Recall 22KWF: T680 NextGen Split Fender Mudflap Fuel Tank Rub

22KWF / 22V582 / 2022-430

Kenworth Truck Company

9/19/2022

Left Hand Under Cab (LHUC) Fuel Tank

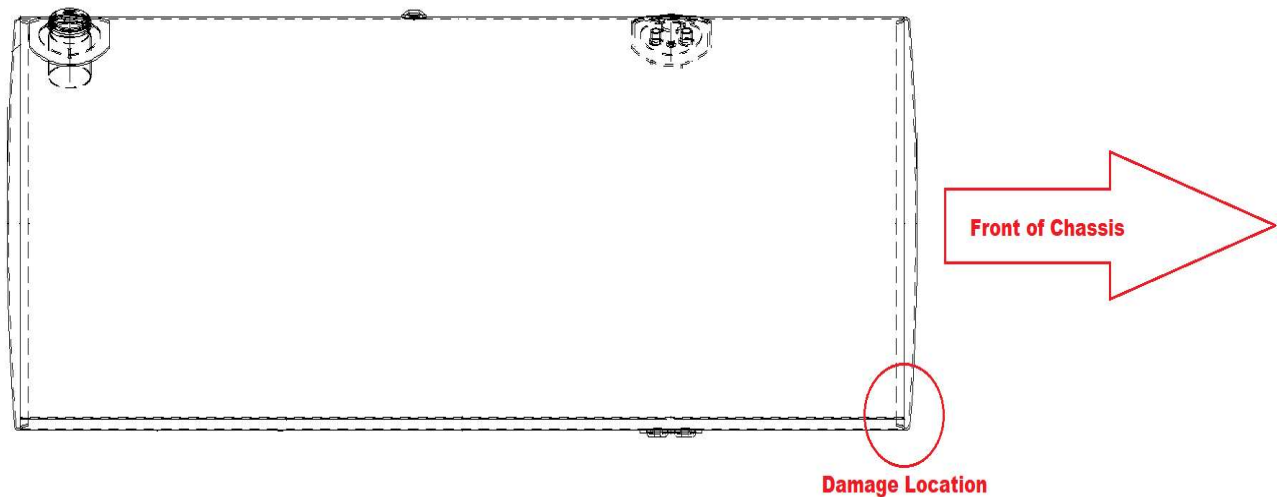
1. Clean the exterior of the fuel tank and inspect the forward lower area of the fuel tank.

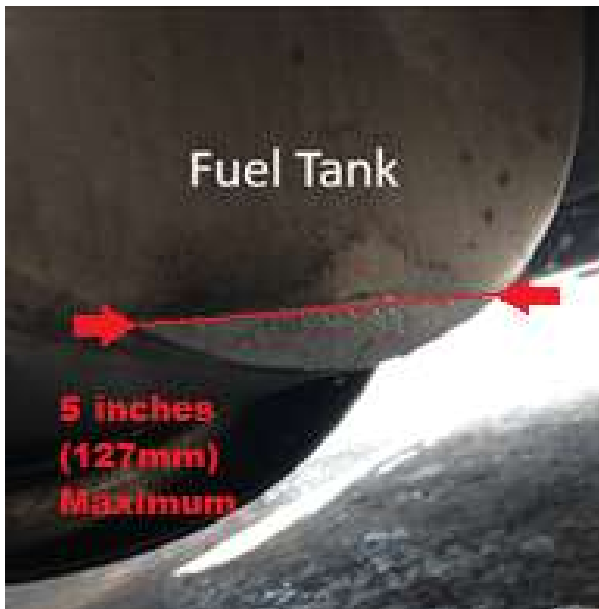
Fuel tanks with damage that meets one or more of the following criteria should be replaced:

- Any fuel leak from the rubbed area, regardless of damage area size.
- Rubbed area is 5 inches (127 mm) wide at the widest point. (See picture below)
- Any gouges or deep scratches that are more than 1mm deep ($\frac{1}{2}$ the original thickness of the fuel tank material) - measure using a tire tread depth gauge or similar tool.

- Obtain a new fuel tank and mudflap (if damaged) using the part number(s) listed in ECAT for the specific chassis.
- Replace fuel tank.
- Prime fuel system after new fuel tank installation.

2. Install anti-sail device on both front mudflaps (Left and Right side)

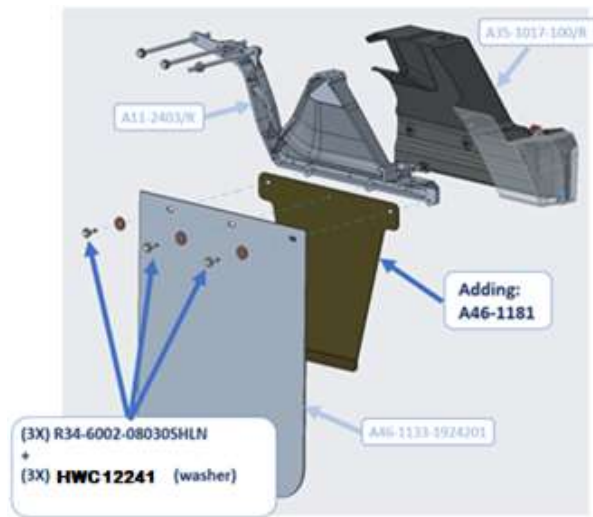
All affected chassis will have anti-sail devices installed, regardless of fuel tank damage.

- Remove the cover PN A35-1017 for access to outboard mudflap fastener.
- Remove 3 fasteners that hold mudflap and fastener plate to split fender frame.
- Retain mudflap for reuse or use replacement mudflap if damaged.
- Install anti-sail panel (PN A46-1181) between frame and mudflap
Anti-sail device should be positioned on the rear side of the mudflap.
- Reinstall mudflap and anti-sail plate using longer fasteners (PN R34-6002-08030SHLN) and

washers (PN HWC12241)

- Install cover PN A35-1017.
